MINOR VARIANCE REPORT

APPLICATION: CAVA/129/2024

CAV A/129/2024- 3240 William Coltson Avenue (East District) (OP Designation: Trafalgar Urban Core Area)

P1 Level – Affected Parking Stalls (highlighted in yellow)

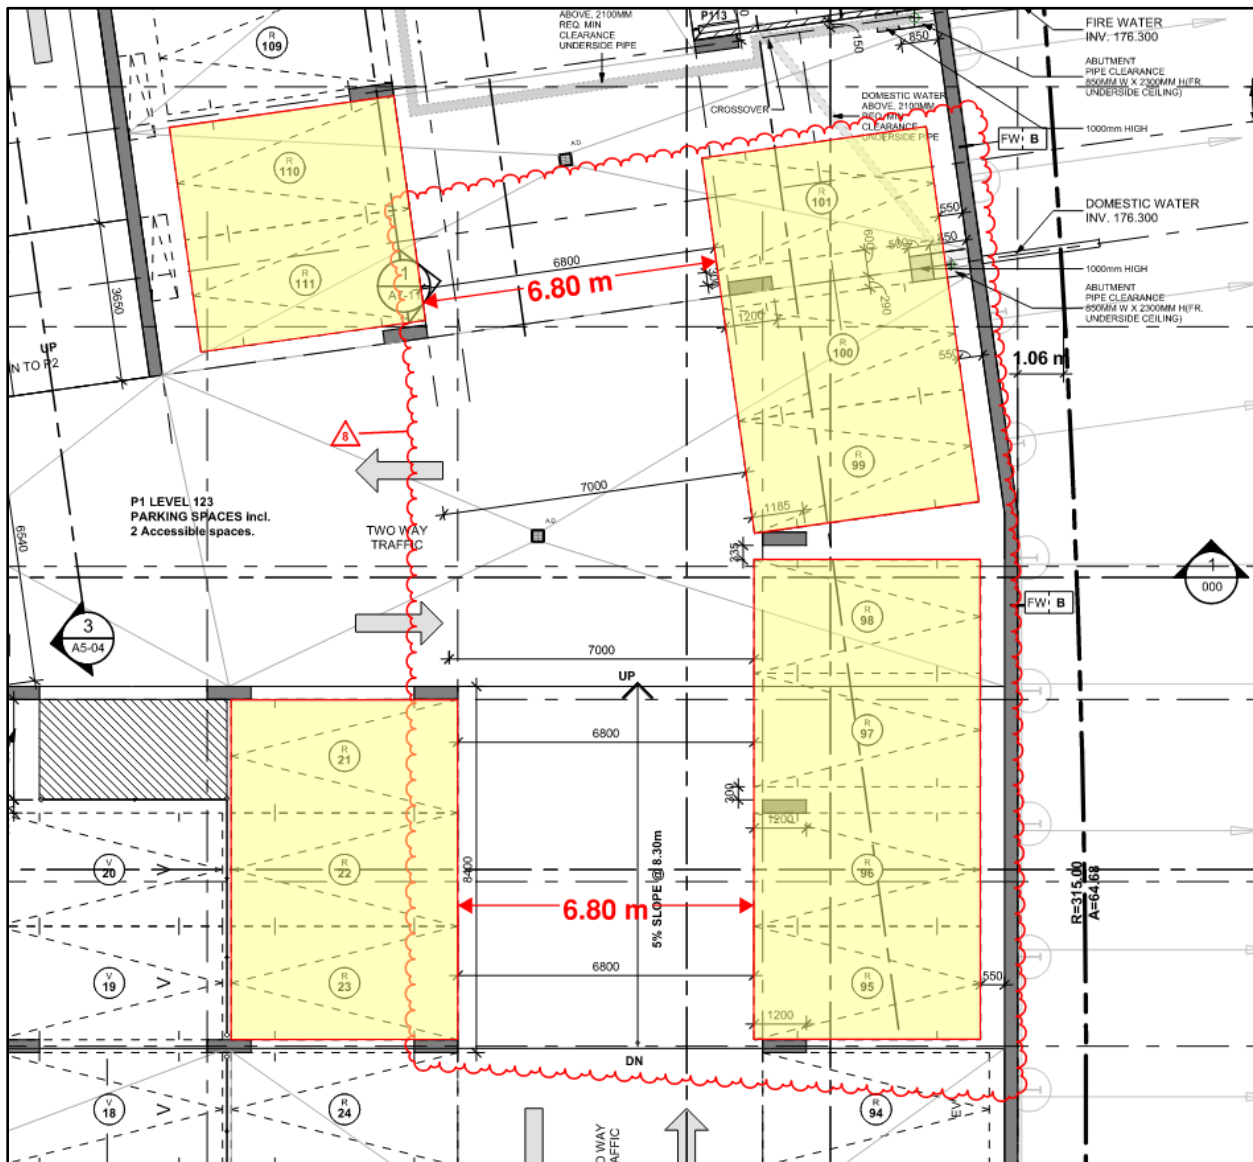
Staff note a storm sewer pipe has been installed on the wall behind the parking stalls R95 to R101 on Parking Level P1. Due to this storm sewer pipe, the affected parking spaces have been modified resulting in a reduced width for the drive aisle from the required 7.0m to 6.8m. Additionally, as a result of the modified parking spaces the columns adjacent to parking spaces R95, R96, R99, and R100 have increased in size from 1.15m to 1.20m. Pursuant to the Zoning By-law parking spaces adjacent to impediments such as a wall or column require an increase to the width of the parking space by 0.3m

The variance request proposes to eliminate the need for the additional 0.3m width for parking spaces for the effected spaces and to decrease the width of the parking aisle from 7.0 m to 6.8 m adjacent to the foregoing parking spaces, as shown below:

Variance #1 – Width of a parking stall to not increase by 0.3m adjacent to a column or other obstruction within 1.15m of the stall end (No Objection) – obstruction increased from 1.15m to 1.20m

Variance #2 – Minimum parking aisle width (No Objection) – 7.0m decreased to 6.8m

The intent of the Zoning By-law provision for parking stall width is to provide an increase in parking stall width where an obstruction causes impacts on the function of the parking stall. The intent of the Zoning By-law provision for minimum parking aisle width is to allow adequate space for two vehicles to pass each other and allow for adequate turning movements to and from parking spaces. It is staff's opinion that the size of the obstruction/column due to the shifting of parking spaces towards the parking aisle for R95, R96, R99 and R100, increased by 5 centimeters (0.05m), is minor and does not cause any undue impacts on the affected parking spaces. It is also staff's opinion that the reduction in parking aisle width in front of nine parking spaces (R21, R22, R23, R95, R96, R97, R101, R110 and R111) does not cause any negative impacts on the function of the parking lot. Staff is of the opinion that the proposed variances meet the general intent and purpose of the Zoning By-law.

1. That parking stalls R95, R96, R99 and R100, as well as parking aisle between parking stalls R21, R22, R23, R96, R96, R97, R101, R110 and R111, be constructed in general accordance with the Floor Plan Level P1 dated June 26, 2024.
